## INVITATION TO TENDER "ITT" PS20170704

### SUNSET PARK UPGRADE

#### QUESTIONS AND ANSWERS NO. 3

June 19, 2017

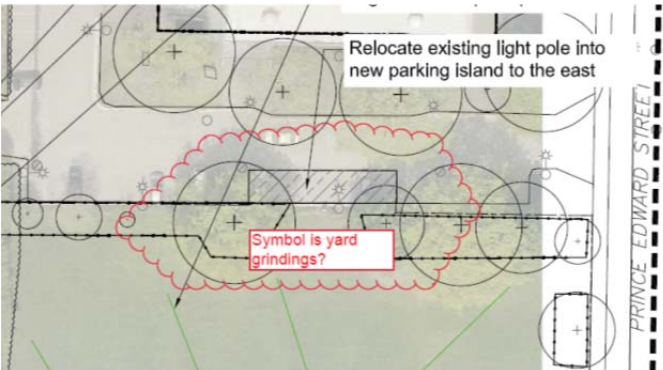
Q1	<p>There is no apparent detail shown for the entire parking area shown below, i.e. extent and detail of the parking surface, boulevard detail to the north, edge detail to the east, soft landscape detail around the parking lot.</p> 
A1	Refer to Addendum No. 3.
Q2	<p>What is required for surface treatment?</p> 
A2	There is to be an asphalt apron at the entrance to the yard. Refer to Addendum No. 3 for details.

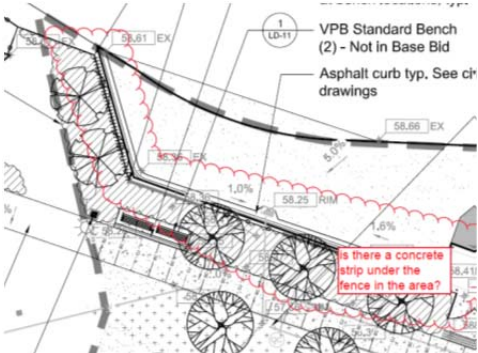
Q4	<p>What is this symbol referring to (see below):</p> 
A4	<p>This area is for proposed temporary lock block storage during construction. Exact storage location to be confirmed by the City. Refer to Addendum No. 3.</p>

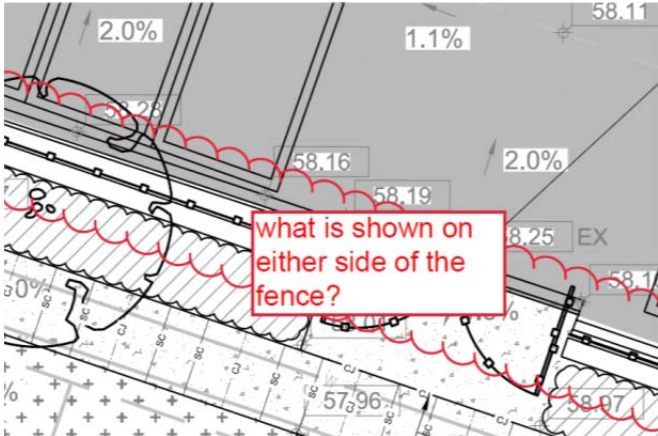
Q5	<p>Is there a concrete strip under the fence in the area (see diagram below)?</p> 
A5	<p>Refer to Addendum No. 3. Drawing CD-04 has been updated and shows typical asphalt curbing and pavement along fence.</p>
Q6	<p>What is shown on either side of the fence (see below)?</p> 
A6	<p>Refer to Addendum No. 3. Drawing CD-04 has been updated and shows asphalt curb and pavement strip at edge of fence.</p>
Q7	<p>Is the concrete curb bordering the asphalt pathway?</p> 
A7	<p>Yes, there is a concrete curb along the south edge of the pathway.</p>

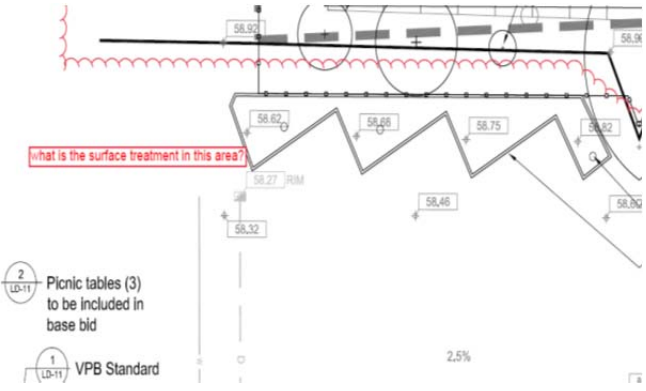
Q8	<p>What is the surface treatment in this area?</p> 
A8	Refer to Addendum No. 3. Drawing CV-02B has been updated.
Q9	What installers are acceptable for the rubber playground surface?
A9	Refer to Addendum No. 3. An alternate installer has been approved.
